Muon, Magnet and Calorimeter Interface Meeting - SSCL

January 7, 1993

Agenda, attendees, minutes and presentations of the GEM Muon, Magnet and Calorimeter Interface Meeting held at the SSC Laboratory on January 7, 1993.

MINUTES OF THE MUON, MAGNET, AND CALORIMETER INTERFACE MEETING

BEAMLINE LAYOUT

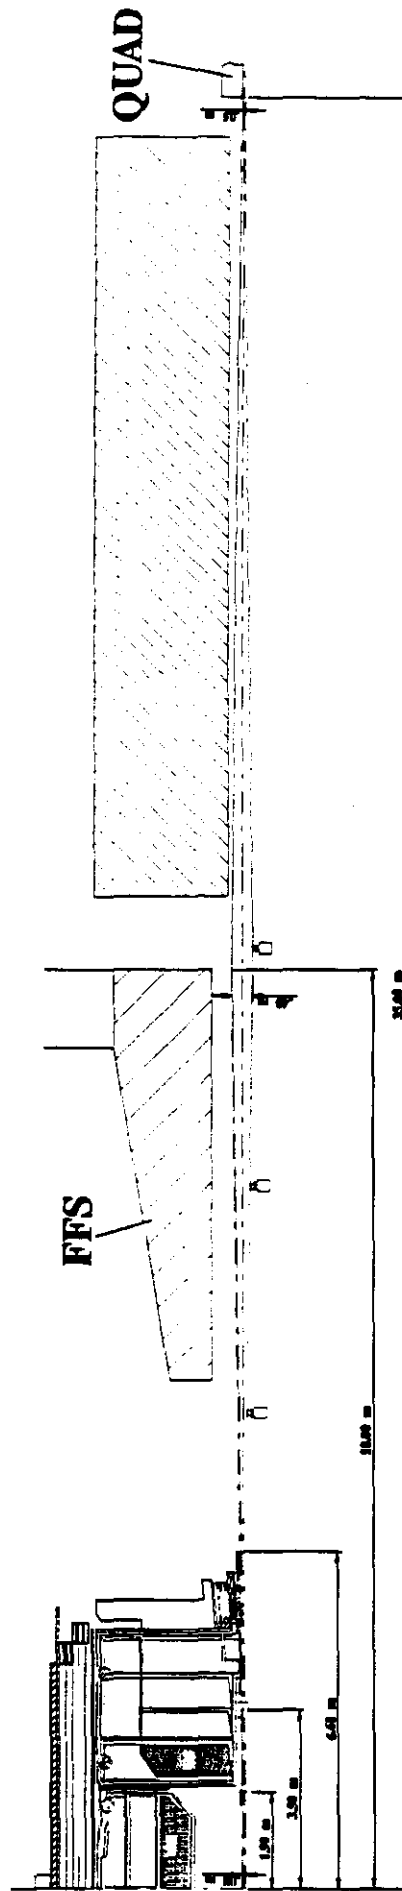
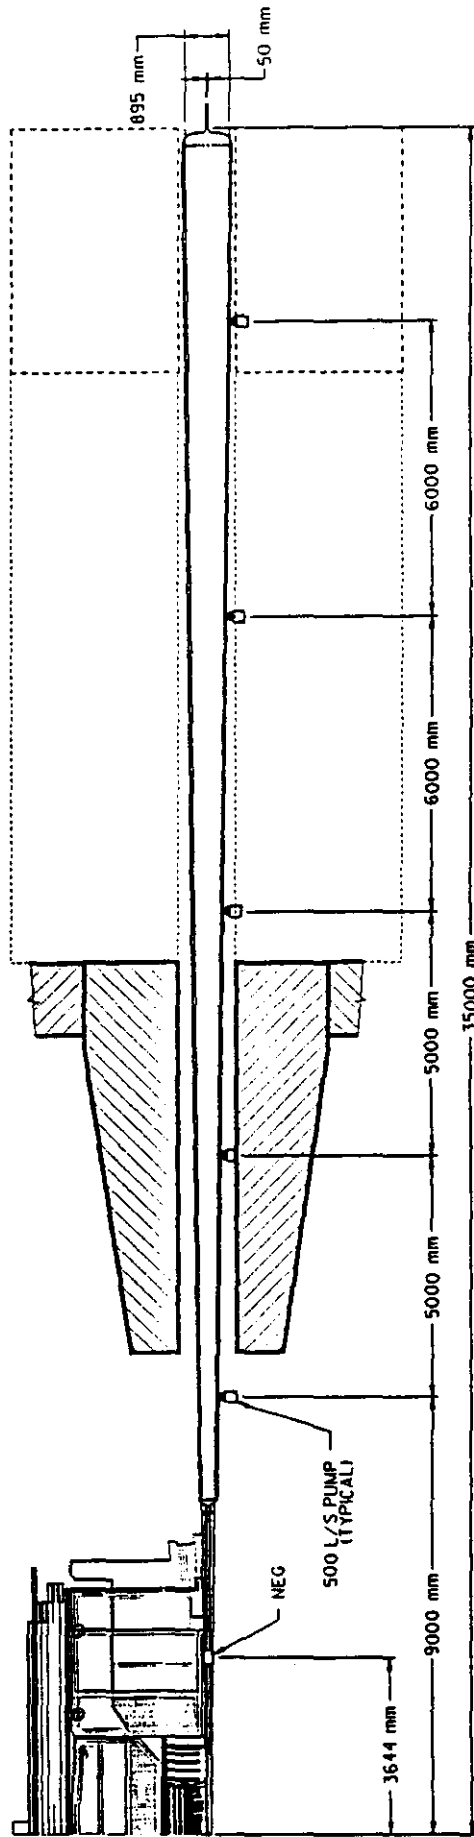
G. Chapman: Two beam pipe options were shown. Option #2 featured a flared then tapered pipe while Option #4 showed a flare only with a 794mm OD, maximum thickness of 6.3mm, and a safety factor of 2 regarding stress. Option #4 is the current design and allows no access through the FFS bore. M. Marx promoted moving the entire FFS assembly back each time any access is required to the far end of the detector. This requires removal of the large pumps outside the FFS on the back as well as the mechanical difficulty associated with movement of this massive FFS hardware. M. Harris moved that the large FFS bore decision be reviewed vis a vis the new beam pipe design information. G. Chapman was asked to determine the minimum FFS bore feasible for use with his current configuration.

G. Chapman will reduce the 1.2m FFS bore to a minimum through his creative genius.
